# ringaskiddy

## waste management facility

**RESPONSE TO THE NOTICE UNDER ARTICLE 14(2)(B)(II) OF THE  
WASTE MANAGEMENT (LICENSING) REGULATIONS**

**ARTICLE 13 COMPLIANCE REQUIREMENTS**

Figure 2.6.1 Heat Balance for Fluidised Bed Furnace and Post Combustion Chamber

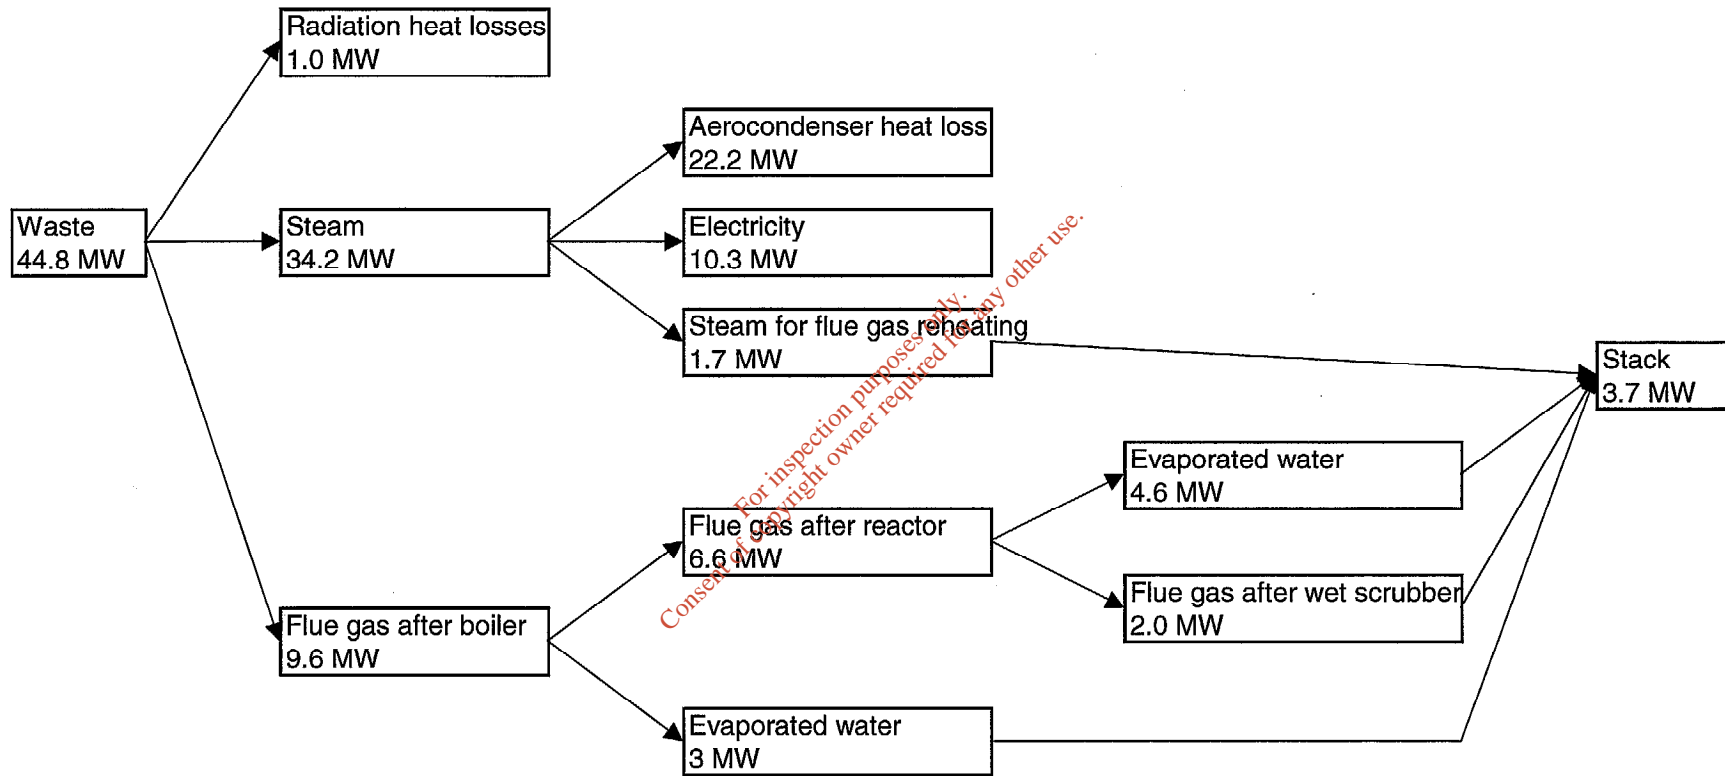
6. *Provide details on heat emissions, including source, location, nature, composition, quantity, level and rate; the impact of such emissions on the environment; and details on the monitoring of any such emissions.*

The thermal input to the fluidised bed and post combustion chamber line will be 44.8 MW. For this furnace line the heat balance is expected to be as follows:

The heat loss by radiation from the hot equipment (furnace, boiler, steam cycle, etc.) will be 1.0 MW (2.2 %). This will make the air in the building hot. This heat will be evacuated through the natural draft building ventilation to the atmosphere.

34.2 MW will be converted to steam. The remaining heat of 9.6 MW in the flue gas cleaning system and 0.9 MW heat radiation in the buildings will not be recovered.

The 34.2 MW steam will be converted in 10.3 MW electricity, 22.2 MW hot air and 1.7 MW steam for flue gas reheating. The hot air will come from the aerocondenser. Steam at 40 bar / 400 °C will enter the turbine. Steam at 0.15 bar / 50 °C and for only 10 % condensed will leave the turbine. The remaining 90 % steam will be condensed in the aerocondenser. It will be indirect cooling. The steam will be condensed in a closed loop and the ambient air will be heated.

The 9.6 MW at the outlet of the boiler will be reduced to 6.6 MW in the spray dryer. The difference of 3 MW represents the evaporation of water in the spray dryer. Sensible heat of 3 MW will be converted to latent heat.

The 6.6 MW at the entrance of the wet flue gas cleaning system will become 2.0 MW at the outlet because once again water will be evaporated. Sensible heat of 4.6 MW will be converted to latent heat.

Finally 1.7 MW will be added to the 2.0 MW coming from the wet flue gas cleaning system by means of flue gas reheating with steam. (tapped from the turbine at some 8 bar).

**Figure 5.1: Predicted annual mean SO<sub>2</sub> concentration (microg/m<sup>3</sup>)  
Maximum operation, Indaver Ireland Waste Management Facility**

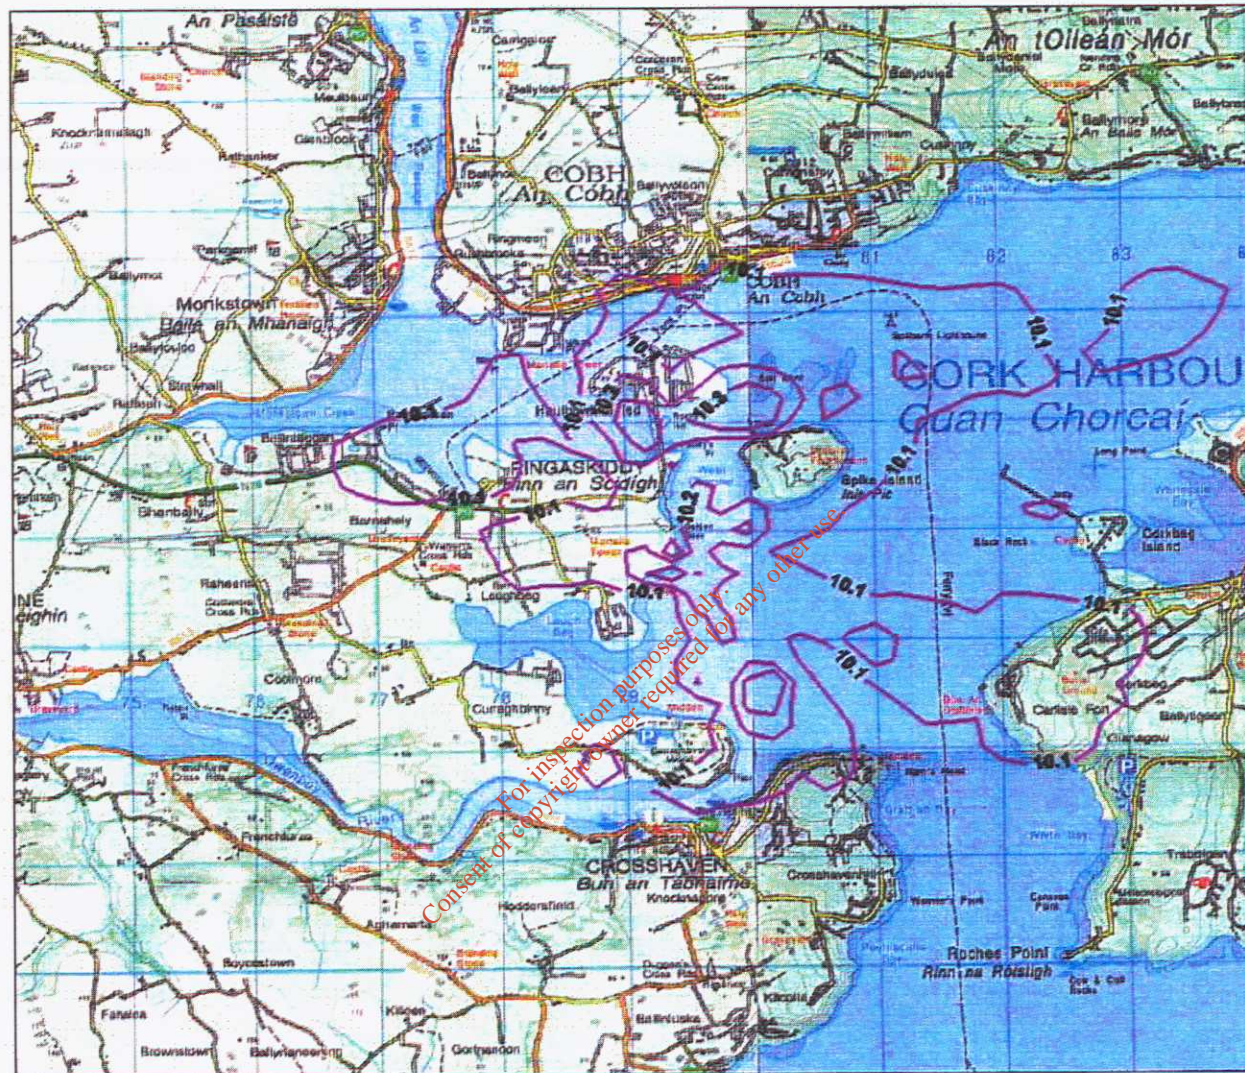
5. *An assessment of the annual average impact of SO<sub>2</sub> should be included.*

The geographical variation in SO<sub>2</sub> ground level concentrations beyond the site boundary is illustrated as a concentration contour in Figure 2.5.1. Figure 2.5.1 is provided in Appendix 2

SO<sub>2</sub> modelling results indicate that the ambient ground level concentrations are below the relevant air quality standards for sulphur dioxide under both typical and maximum operation of the site. Thus, no adverse environmental impact is envisaged to occur under these conditions at or beyond the site boundary. Emissions at maximum operations equate to an ambient SO<sub>2</sub> concentration (including background concentrations), which is 62% of the annual limit value at the worst-case boundary receptor.
